Assessment report to Sydney Central City Planning Panel

Panel reference: 2017SWC134

DA number	SPP-17-00010	Date of lodgement	31 May 2017
Applicant	Michael Bugden		
Owner	M Metro Award Rouse Hill Pty Ltd and CDMA Australia Pty Ltd		
Proposed development	8 residential flat buildings and 2 townhouse buildings		
Street address	44 and 56 Cudgegong Road, Rouse Hill		
Notification period	15 to 29 August 2017	Number of submissions	None

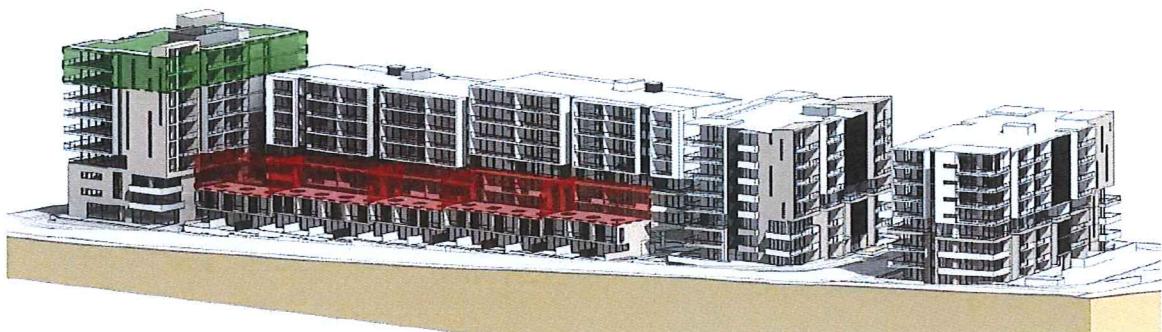
- The increase in height does not impact on the density of the development as demonstrated in the following massing study plans.

Figure 1: Extract from the proposed Site Plan DA004 demonstrating the portions of the private balconies and architectural design features which encroach into the 6 metre street setback requirement above the third level. These areas are highlighted in blue.

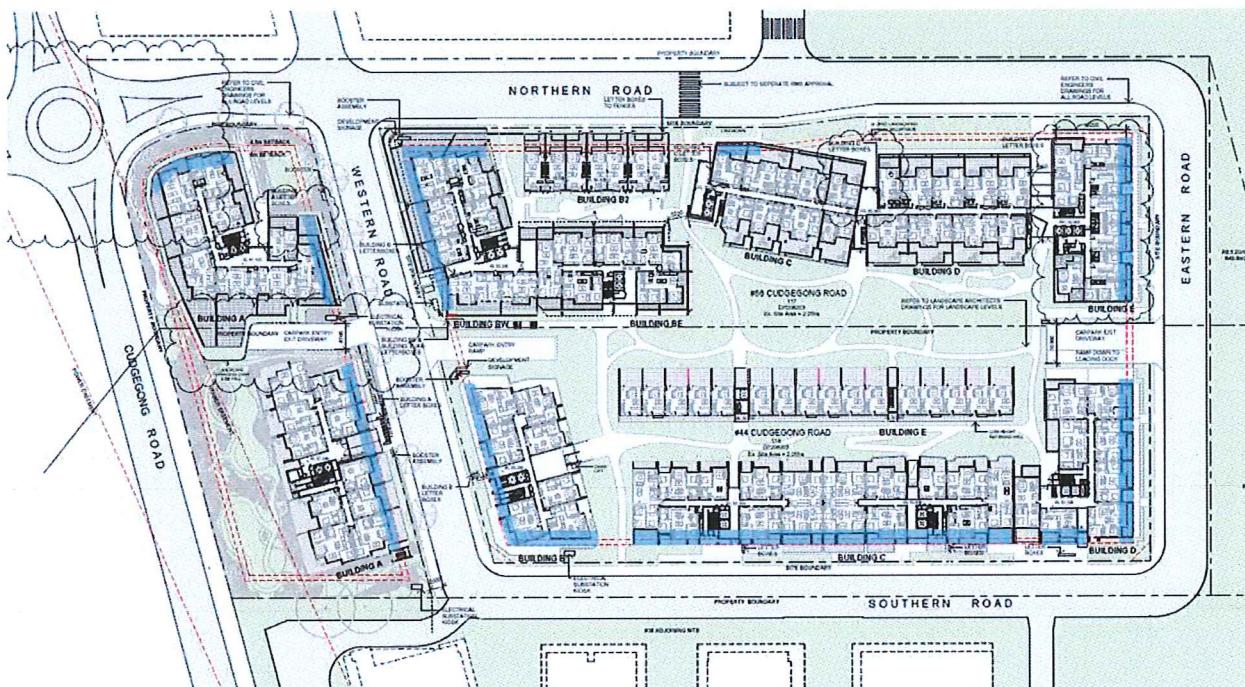
7.2.1 The Applicant seeks a reduced street setback for the majority of private balconies and architectural design features above the third level. The Growth Centre Precincts DCP requires a minimum setback of 6 metres. The proposal provides a setback of 4.5 metres in the locations identified in Figure 1 below:

7.2.2 However, the Apartment Design Guide does not include a numerical requirement for street setbacks, and directs that consideration is to be given to providing articulation zones accommodating space for building entries, ground floor courtyards, balconies, landscaping, deep soil zones and to 'use a setback range where the desired character is for variation within overall consistency.' The proposal is consistent with these guidelines.

7.2.3 Although the full extent of the street setback is not achieved, the proposal offers an interesting and high quality streetscape presentation which is considered satisfactory on its merits.
